March 28, 2013

Re: Dufferin Wind Power Inc. - Application for Leave to Construct (EB-2012-0365) - Second Amendment to Application and Pre-filed Evidence

## **REA Changes Report**

Renewable Energy Approval
Changes Report

# Appendix A Revised Site Plan

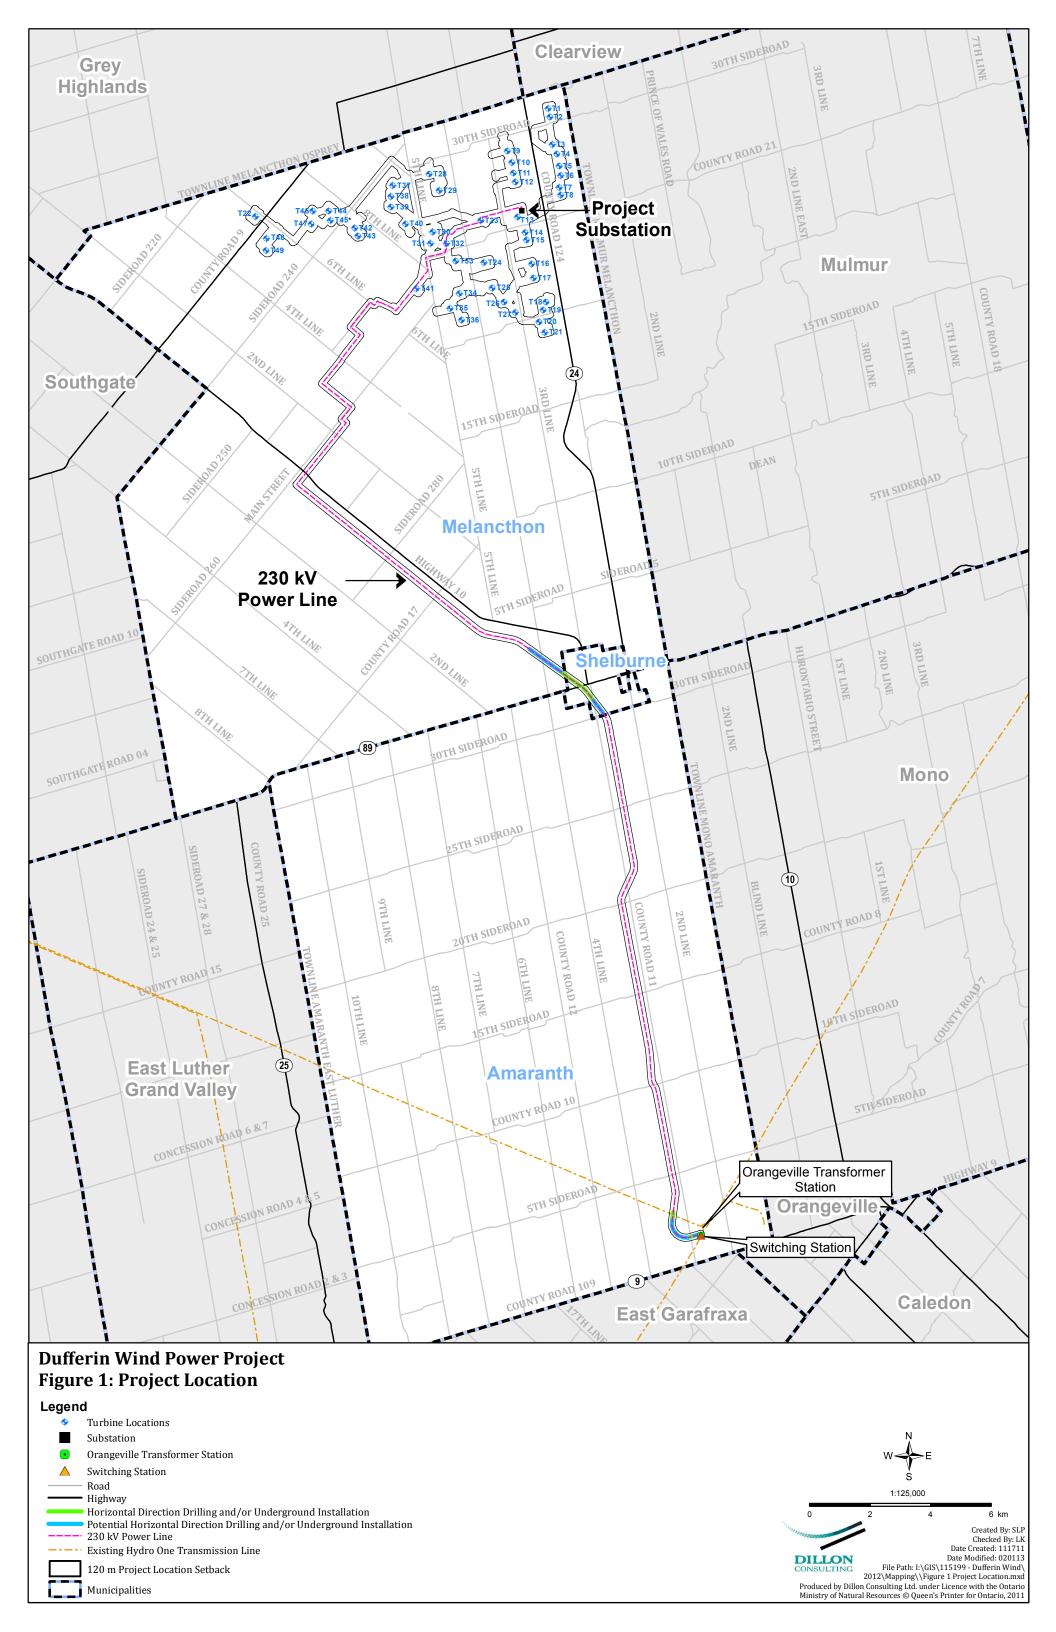
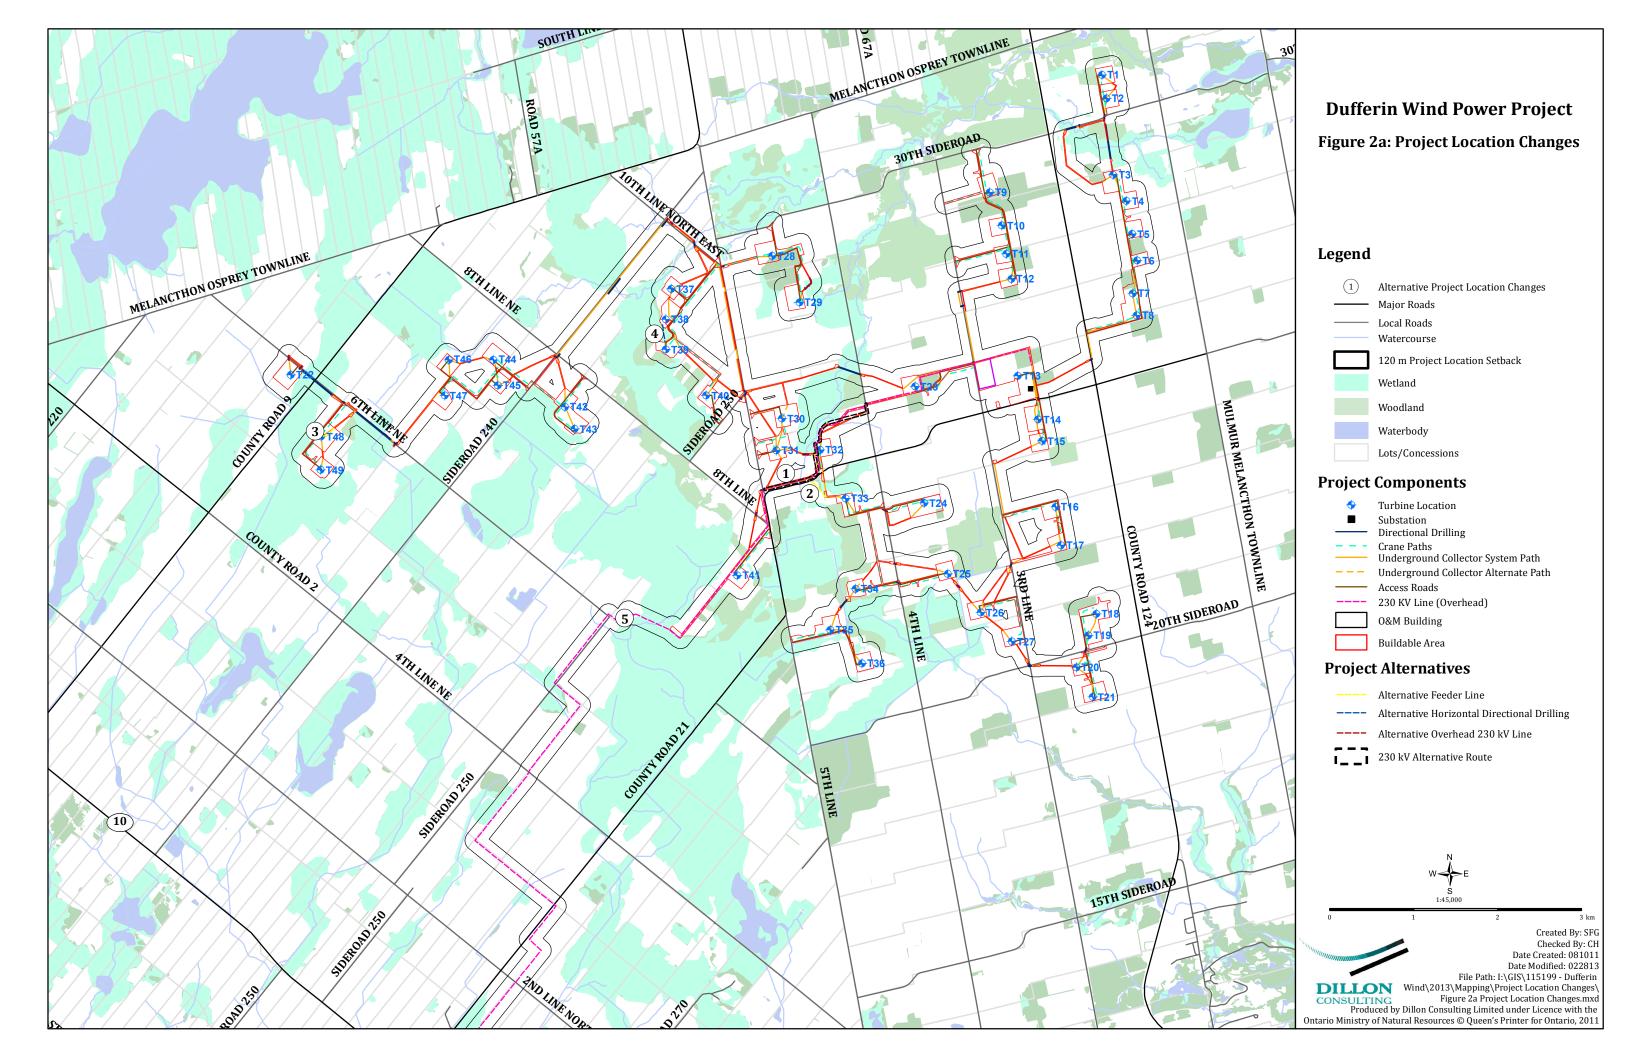
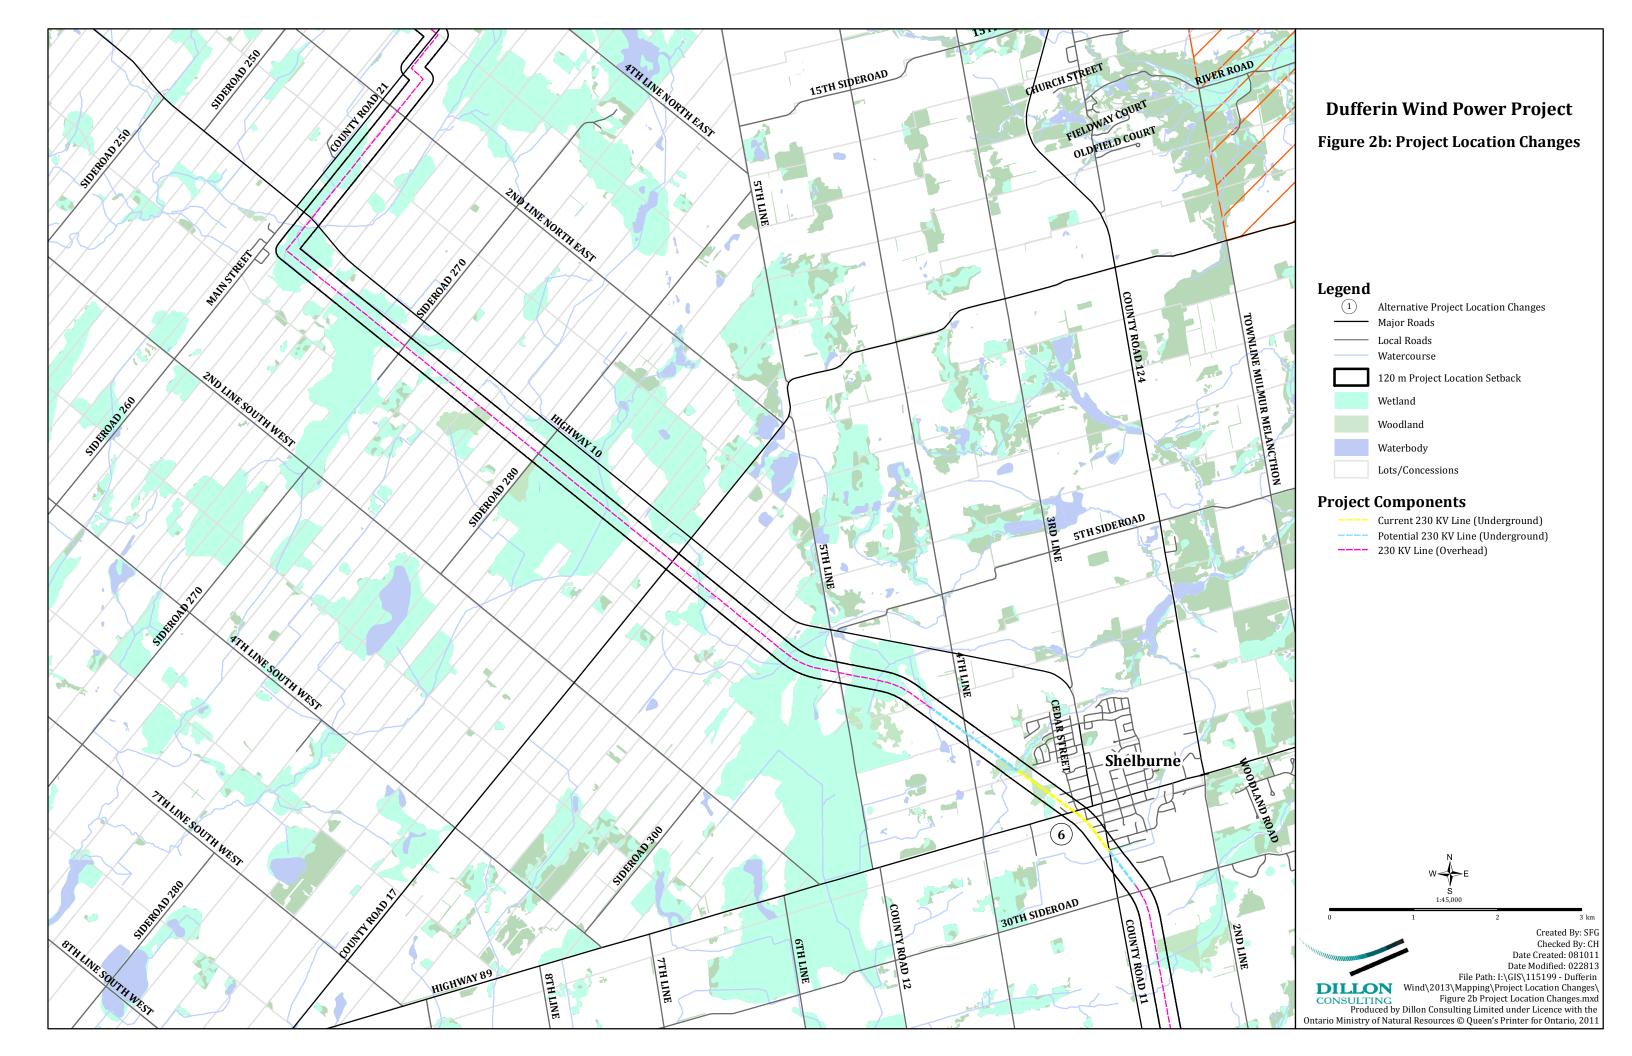
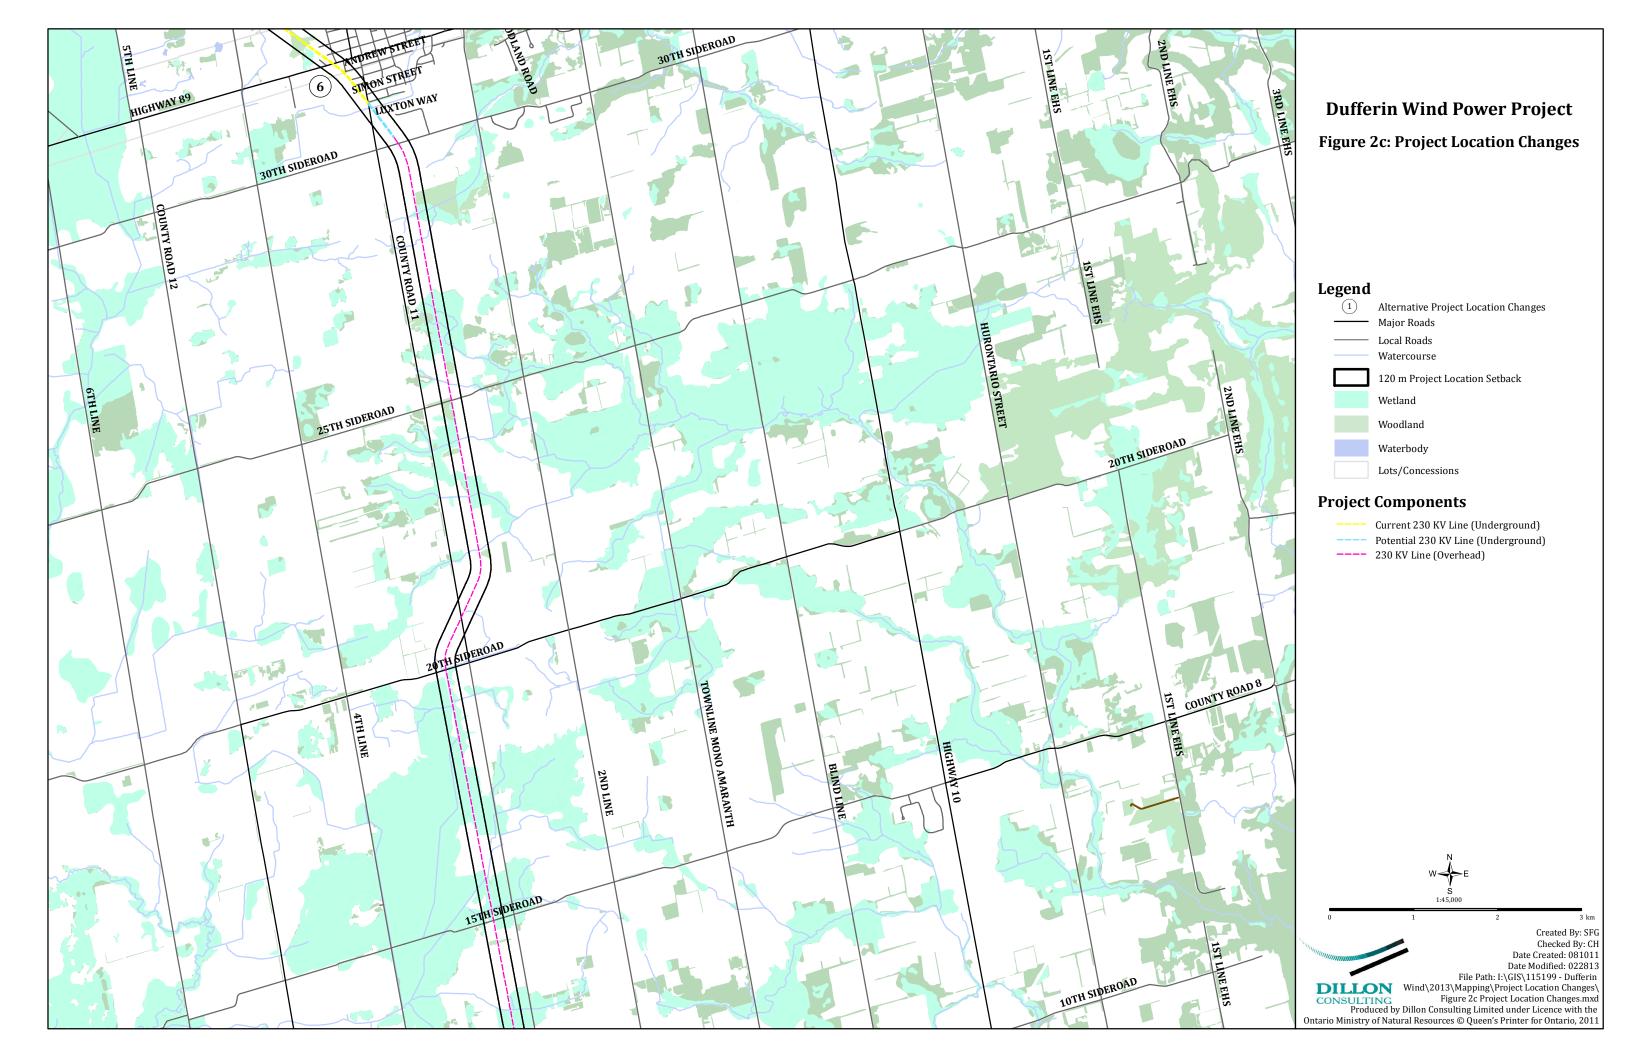
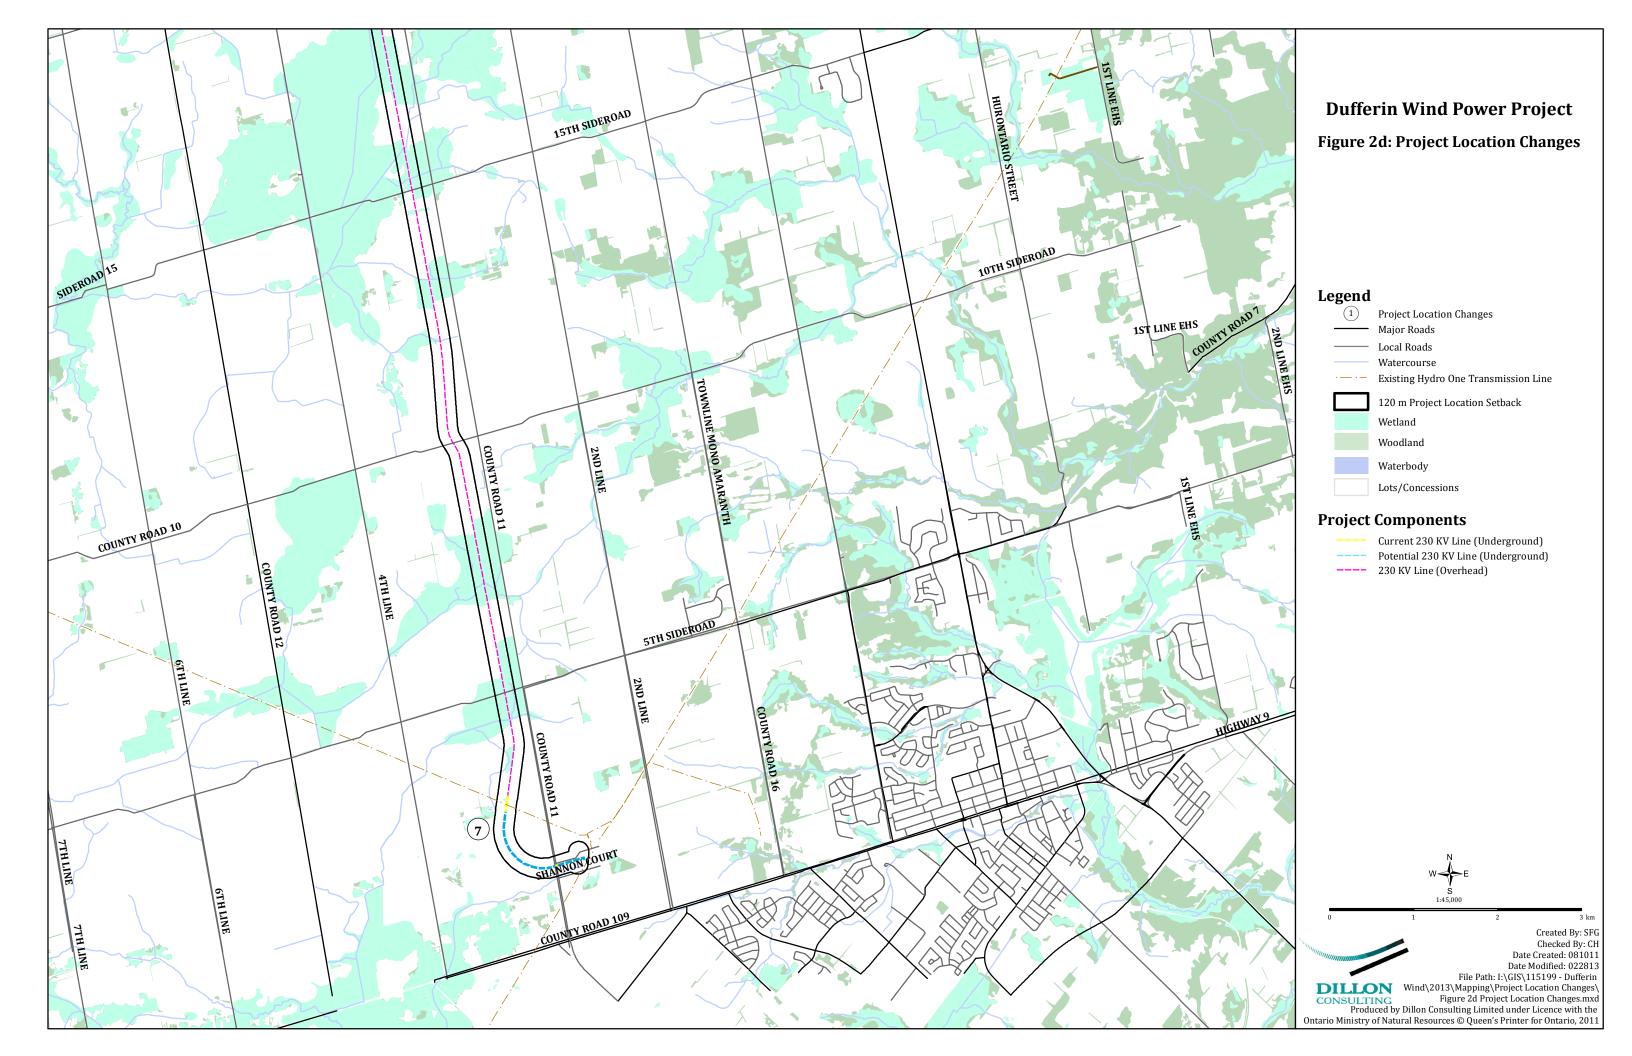
Please see Figures 1 and 2a through 2d in Appendix A for revised site plans of the Project.

### Change 1: Expansion of Transmission Line Easement on T31 and T32 Properties

DWP received a request from a property owner whose preference would be to have the project's power line closer to his property line to minimize impacts on his farming operations. As a result of this request, DWP is proposing to alter the 230 kV transmission line easement and expand the buildable area. This results in the power line easement shifting south on the property west of 4th Line (the property with Turbine 32) (Inset 1) and 20 m closer to the property line on the T32 property. The transmission line is along the edge of Wetland 97/Woodland S (Inset 1). The proposed transmission line infrastructure is situated in a similar location to the previous alignment. The result of this minor shift would increase the amount of productive agricultural land on this property. As the components will remain outside of the natural features, no new effects are anticipated and no revisions to the previously confirmed mitigation approach submitted and approved by the Ministry of Natural Resources (MNR) are needed.
